### LEGAL NOTICE EXETER PLANNING BOARD AGENDA

Continued public hearing on the application of RiverWoods Company at Exeter for site plan review and Wetland CUP application for the demolition of the existing administrative building and the proposed construction of the new supportive living health center along with associated site improvement on the property located at 5 White Oak Drive. The subject property is located in the R-1, Low Density Residential zoning district and are identified as Tax Map Parcel #97-23. PB Case #24-16.

The application of StoneArch Development for site plan review of a proposal for the redevelopment of the property located at 112 Front Street. The proposal includes the demolition of the existing buildings and new construction of seventeen (17) townhouse style condominium units and associated site improvements. The subject property is located in the C-1, Central Area Commercial zoning district and identified as Tax Map Parcel #73-14. PB Case #24-17.

Re: 112 Front Street, LLC – 112 Front Street – Residential Development Response to UEI Comments

### Demolition Plan

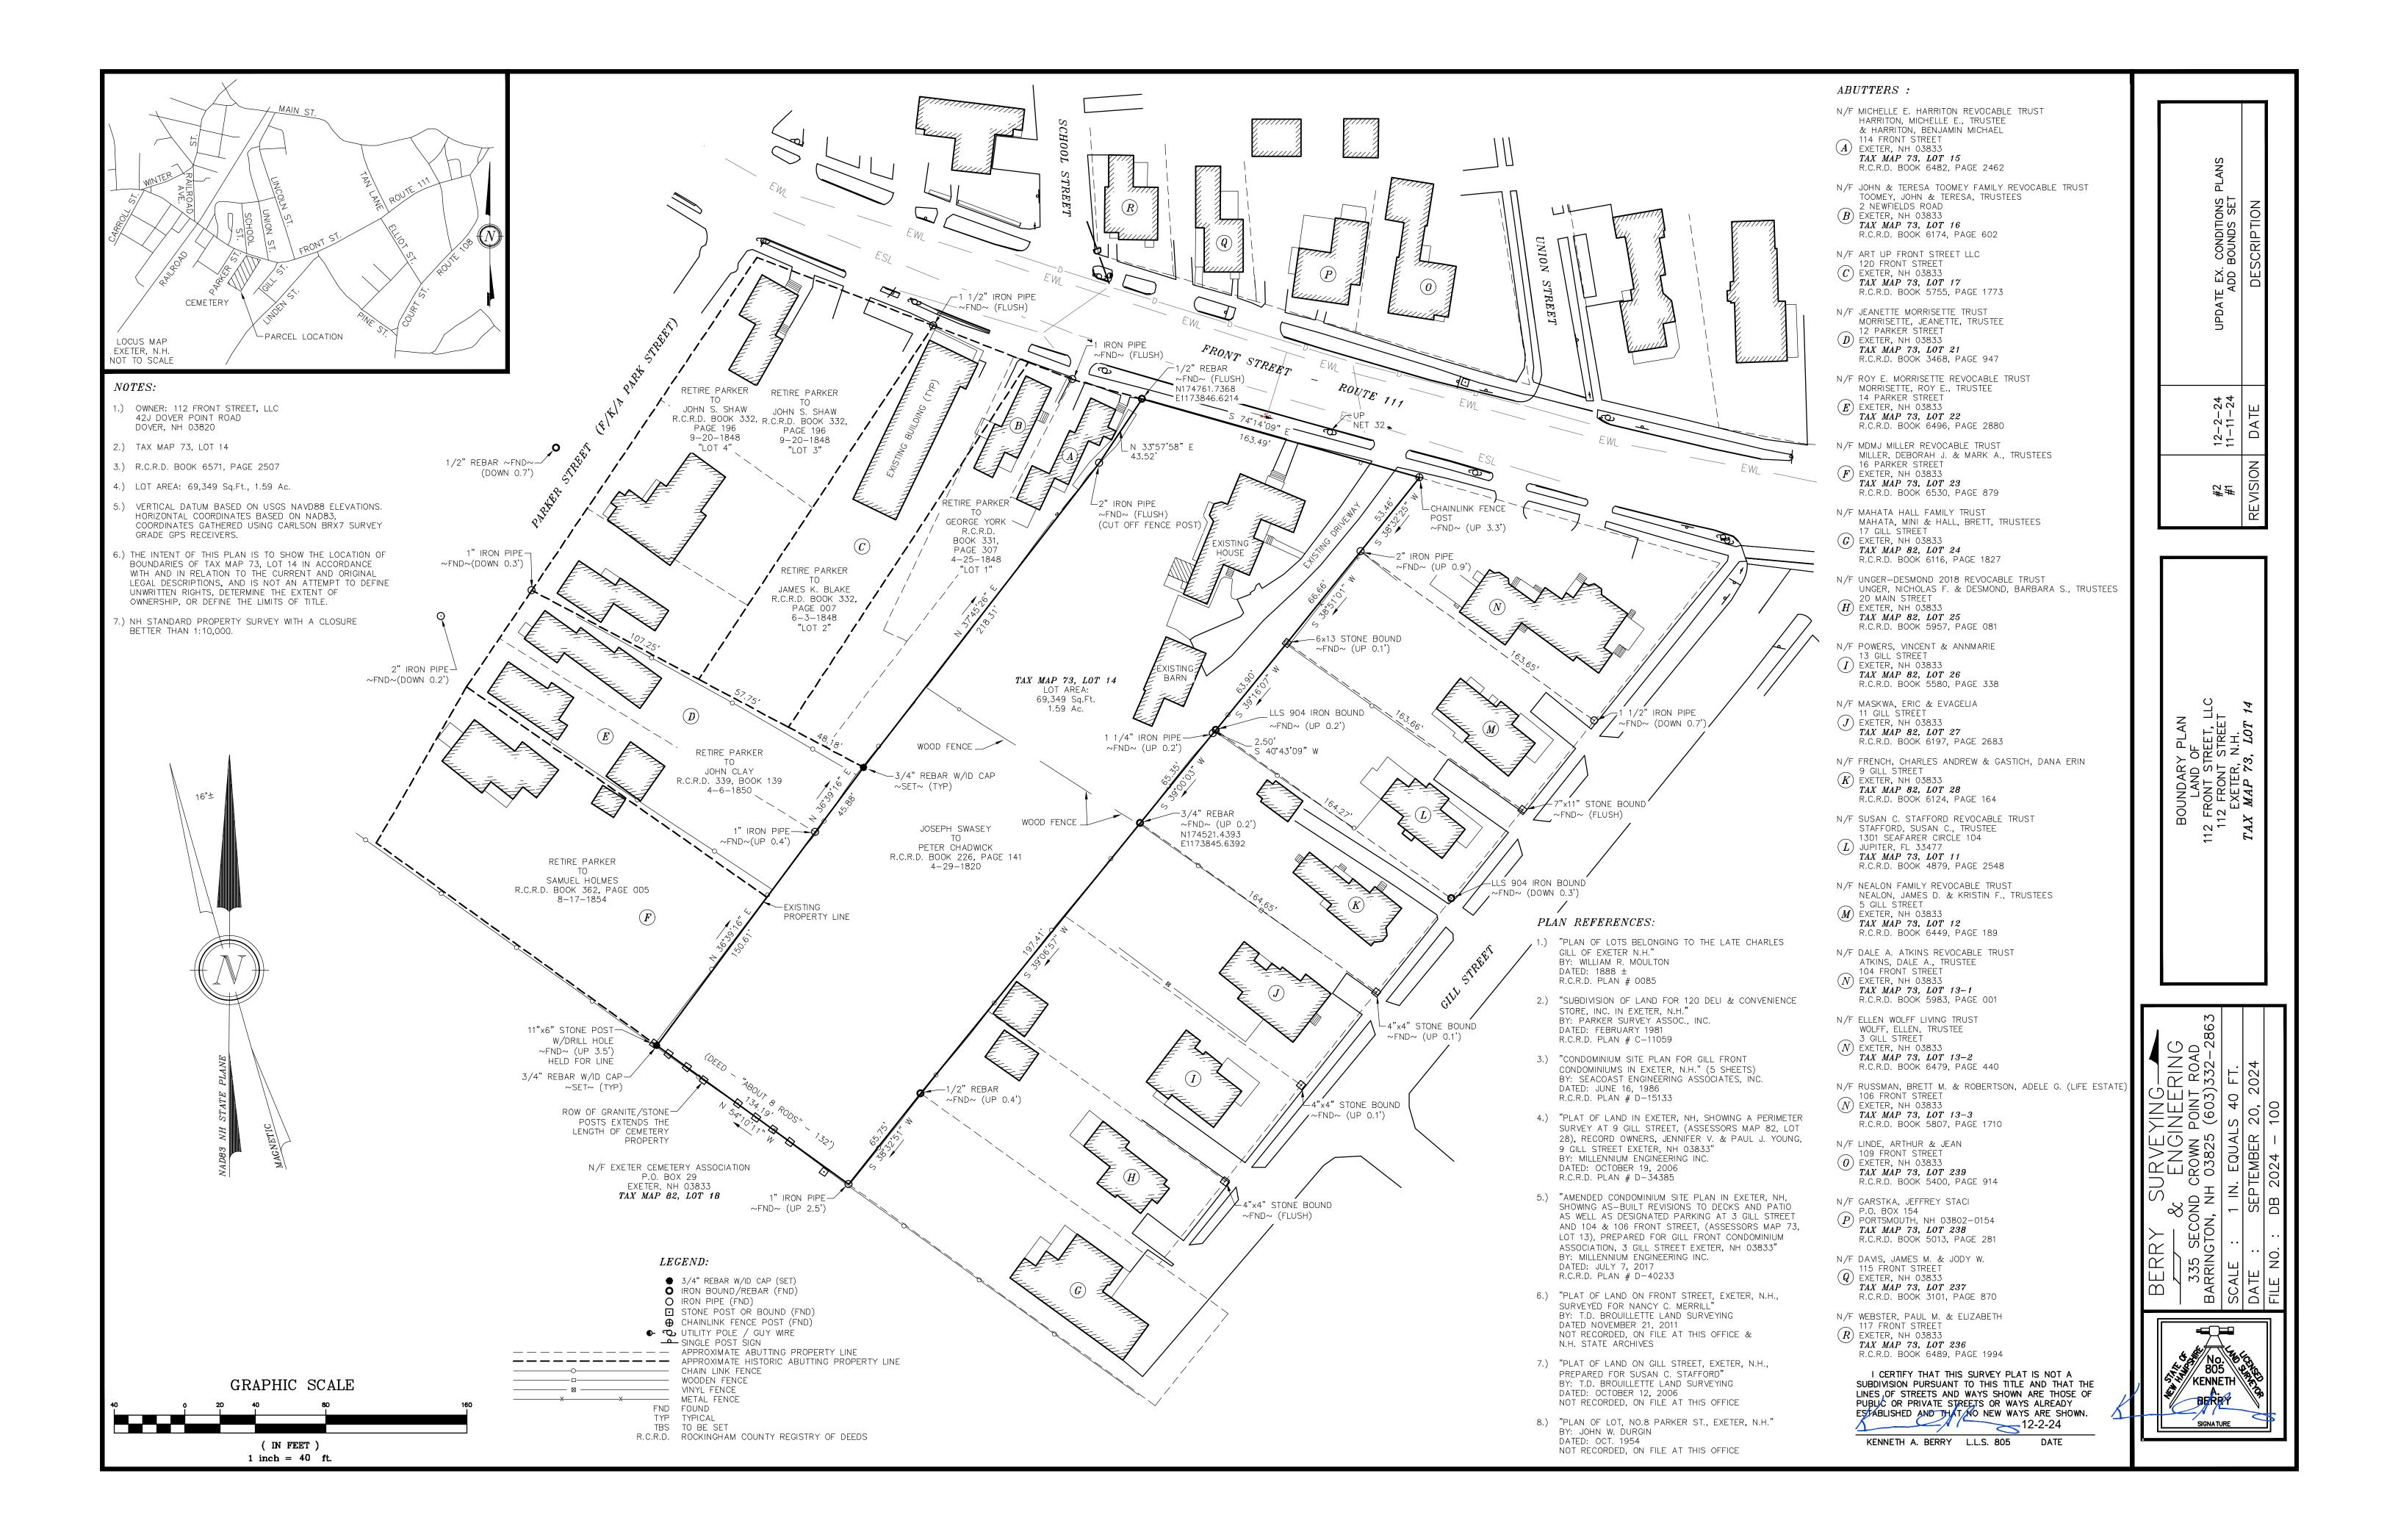
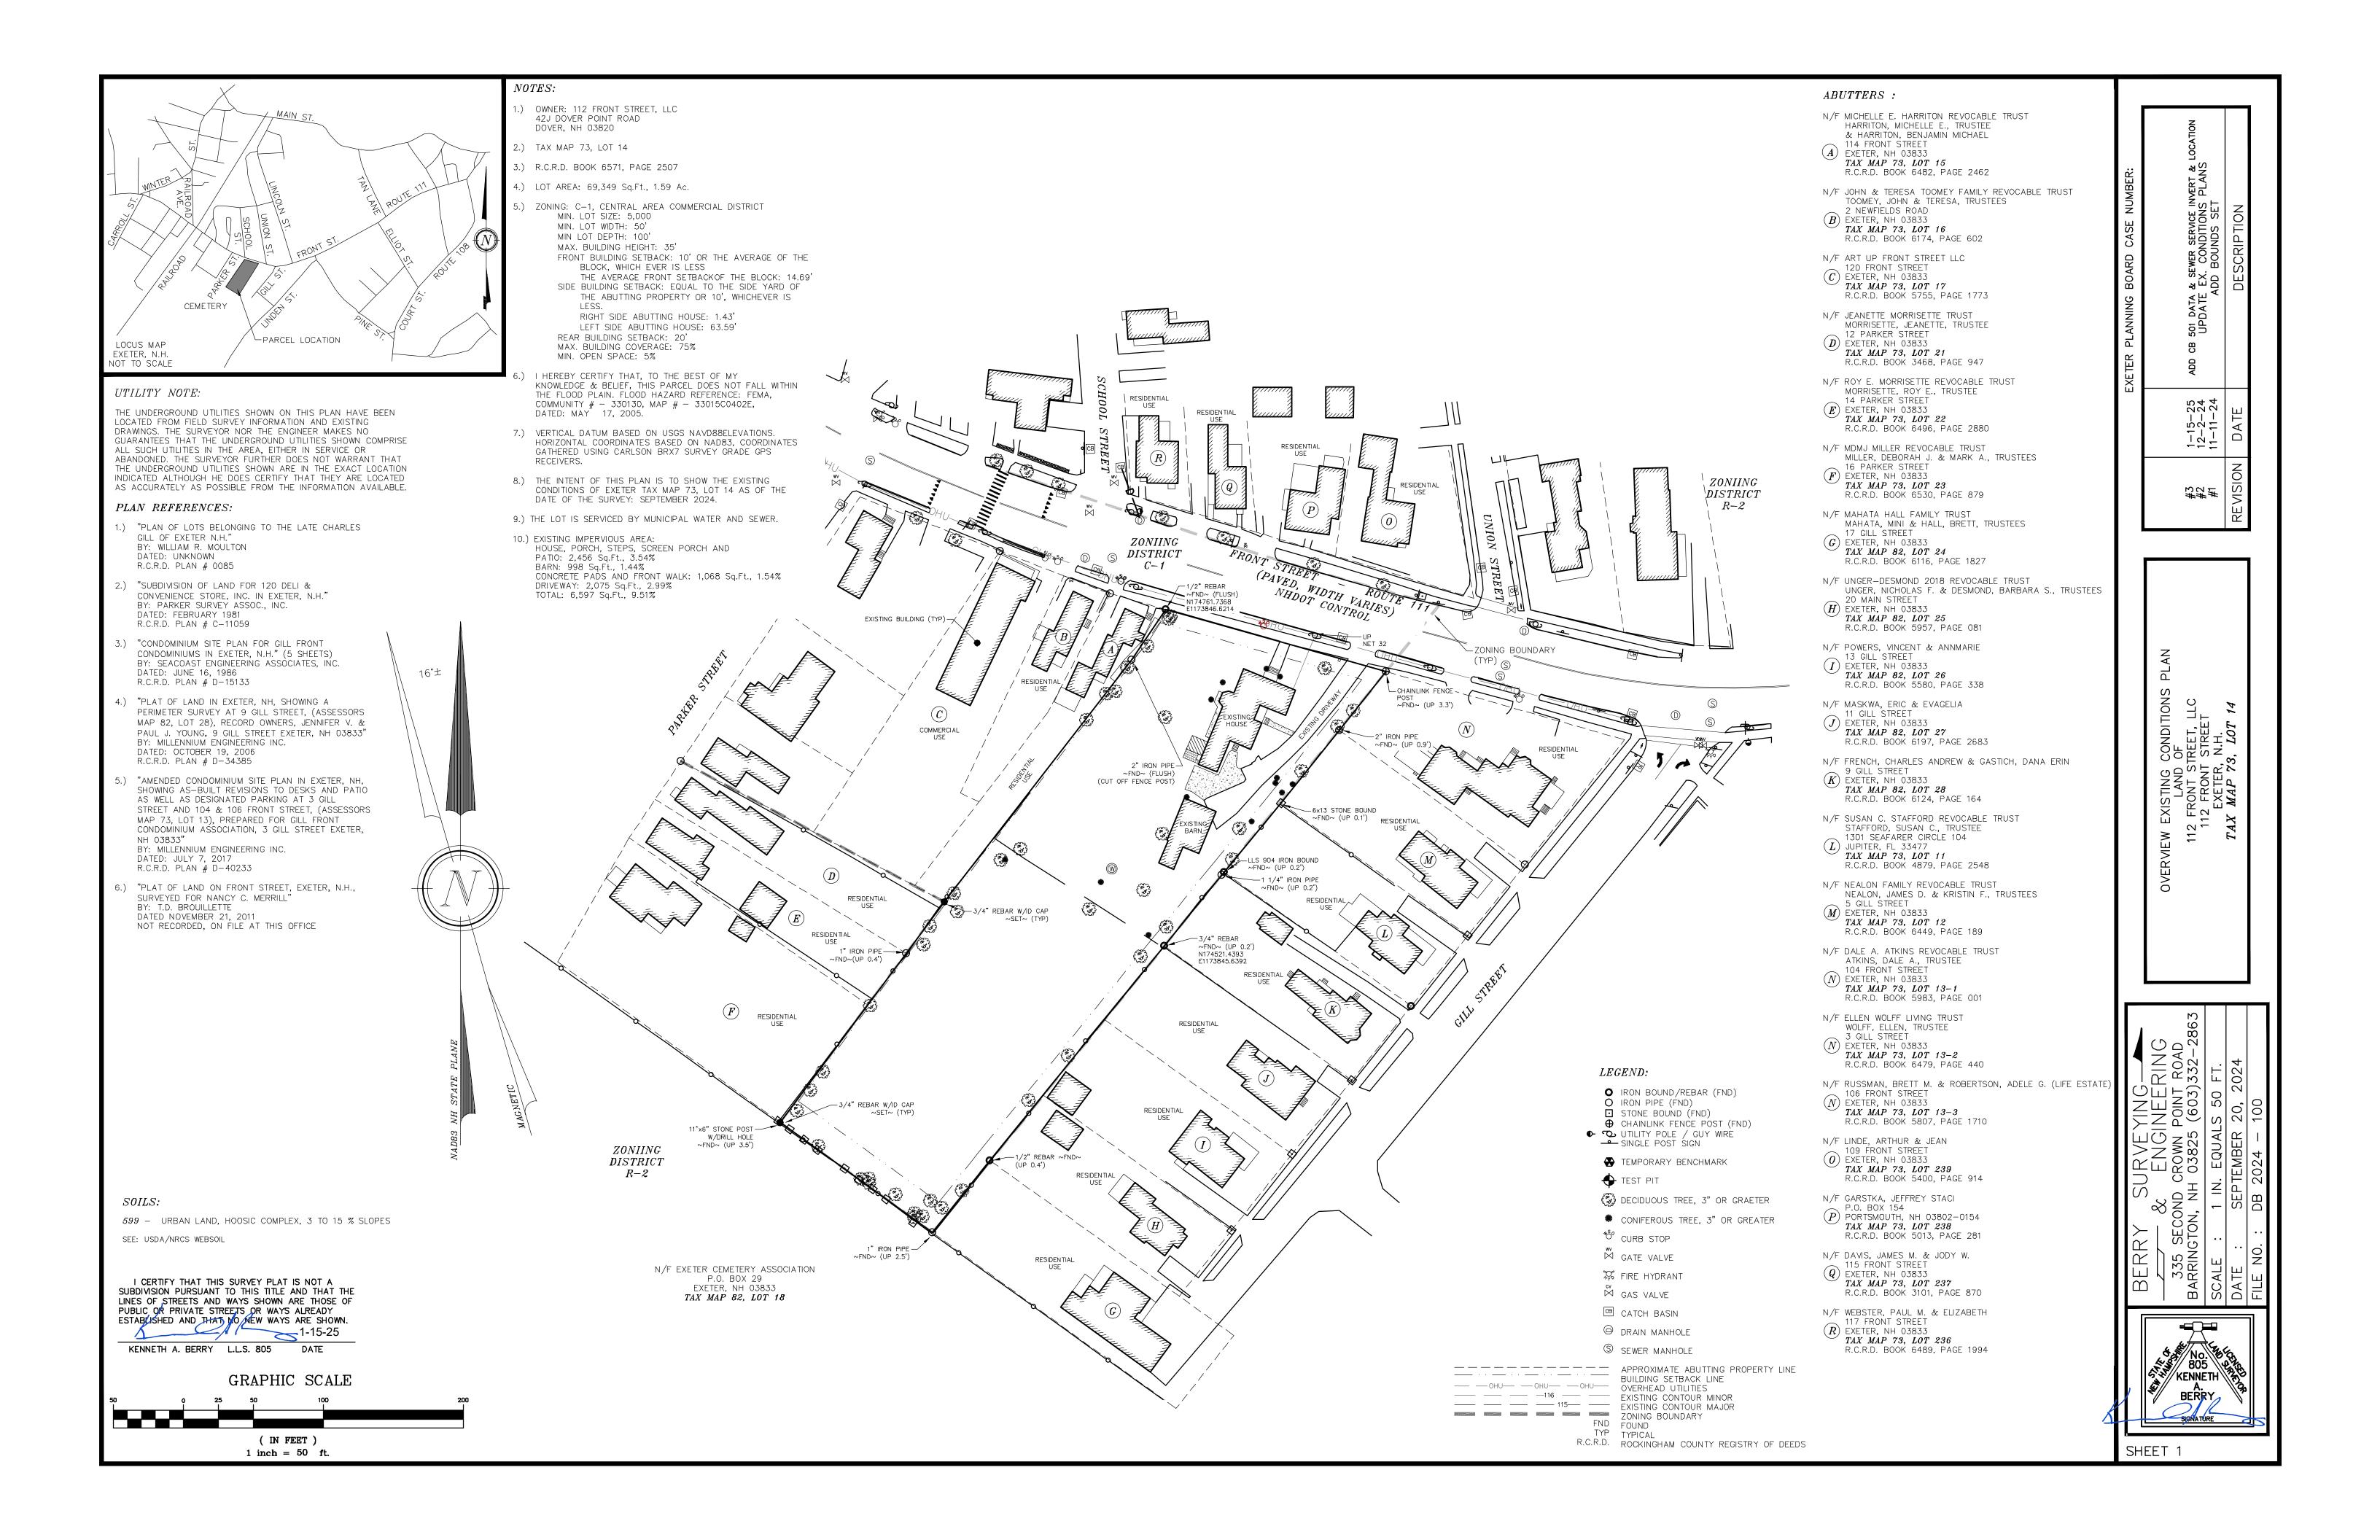
5. Per the comment above, if the encroachment will be removed, please label on plan.

Response: A label has been added to the Demolition Plan to call out the encroachment.
